TVA-BFN-TS-436

BROWNS FERRY NUCLEAR PLANT (BFN) UNIT 1 - TECHNICAL SPECIFICATION (TS) 436 - INCREASED MAIN STEAM ISOLATION VALVE (MSIV) LEAKAGE RATE LIMITS AND EXEMPTION FROM 10 CFR 50, APPENDIX J

BROWNS FERRY NUCLEAR PLANT (BFN) UNIT 1 TECHNICAL SPECIFICATION (TS) CHANGE (TS 436) - INCREASED MAIN STEAM ISOLATION VALVE (MSIV) LEAKAGE RATE LIMITS

FIGURE 1 BFN UNIT 1 MSIV SEISMIC VERIFICATION WALKDOWN BOUNDARY

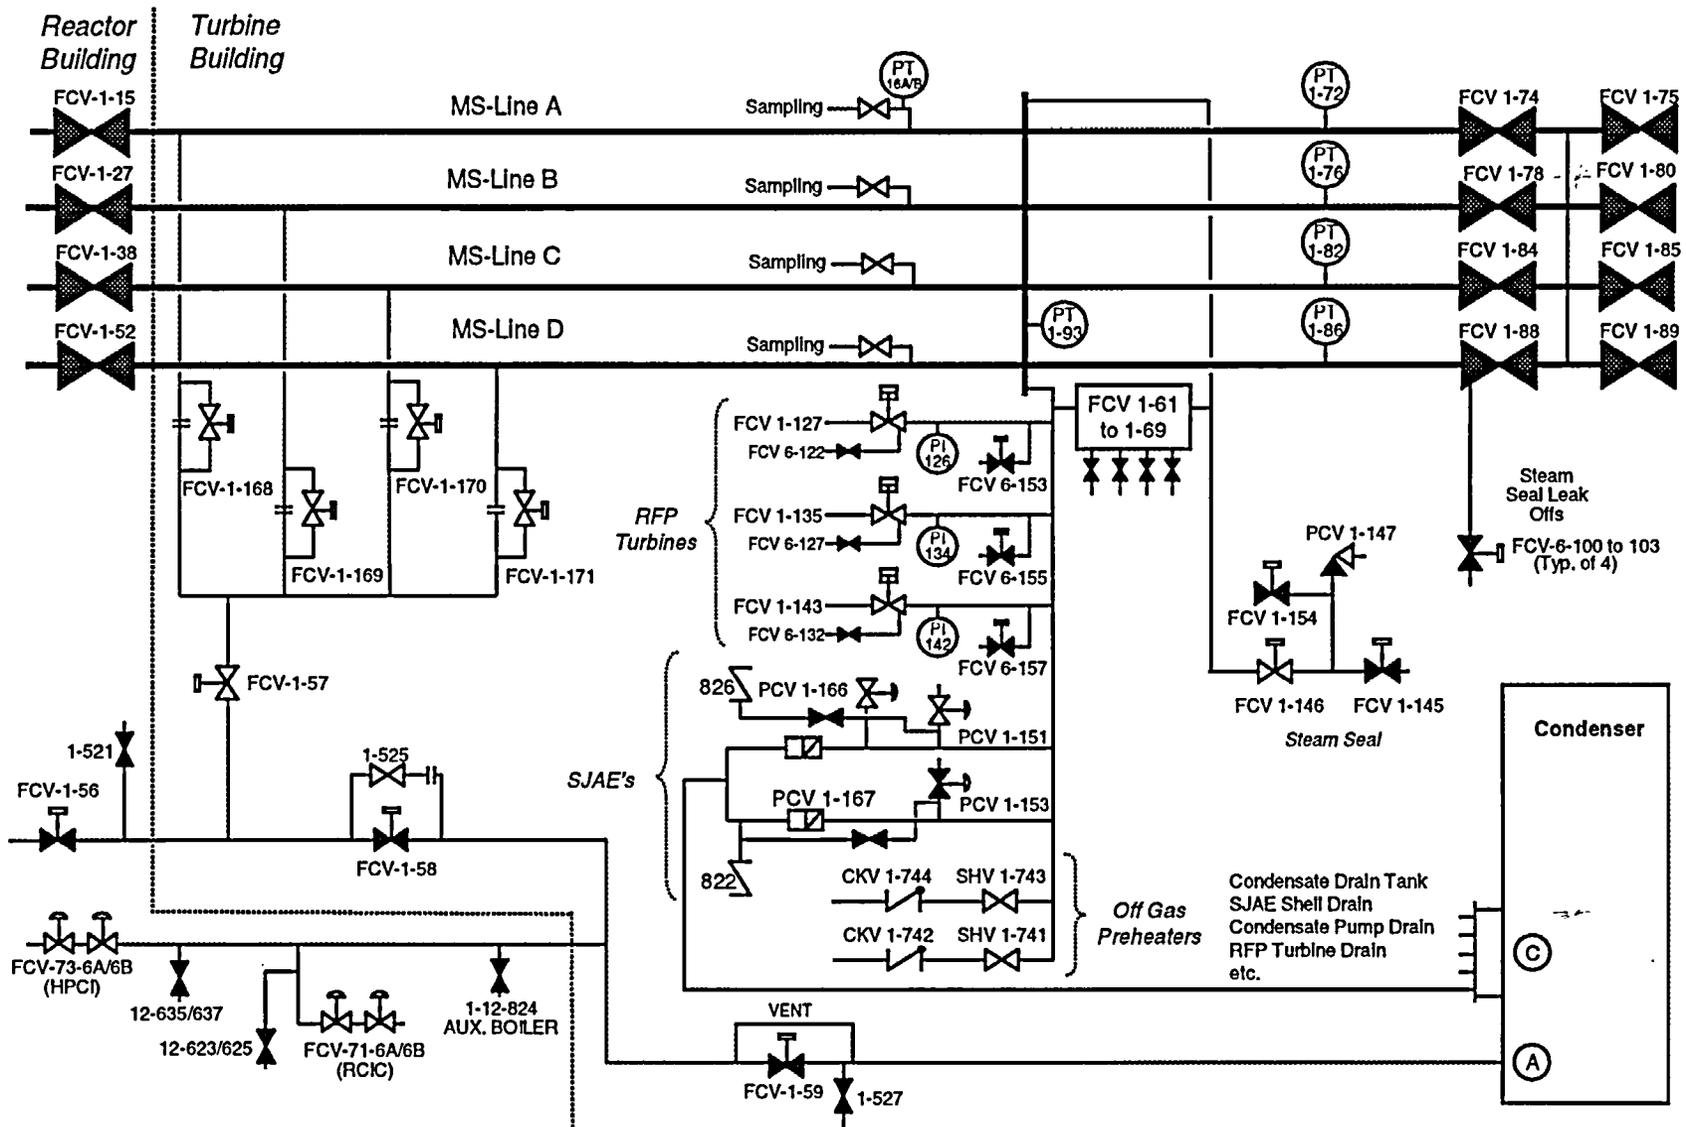
Figure 1 (Page E1-33), MSIV Seismic Verification Boundary, provides a flow diagram schematic which shows the ALT pathway from the MSIVs to the condenser and the boundary valves associated with the ALT pathway for BFN Unit 1. As discussed in NEDC-31858P-A, the ALT pathway establishes a seismically equivalent route to contain and direct leakage from the MSIVs to the condenser following a design basis LOCA.

1. The steam line supplies to the Offgas Preheaters currently do not have adequate boundary valves. Therefore, in-line check valves (CKV) 1-CKV-1-742 and 1-CKV-1-744 are being added to these lines to serve as the boundary valves. Refer to Figure 1 for the location of these valves.

As previously noted, Figure 1 provides a flow diagram that shows the ALT leakage pathway from the MSIVs to the condenser, and the boundary valves. The boundary valves and material properties of the drain line piping and branch lines have been documented. All boundary valves are either closed during normal system operation or fail closed upon loss of power, or loss of control air or hydraulic pressure.

As part of the ALT path isolation boundary, two in-line check valves (1-CKV-1-742 & 1-CKV-1-744) are being added to the steam supply lines for the Offgas Preheaters as shown in Figure 1. These check valves will be spring assisted to remain closed against less than a 5 pound per square inch (psi) differential pressure. This is based on the pressure downstream of the MSIVs being 1 or 2 psi once the steam lines have depressurized and the condenser has lost vacuum. The check valves will be ASME Section III, Class 2 valves. Spring assisted in-line check
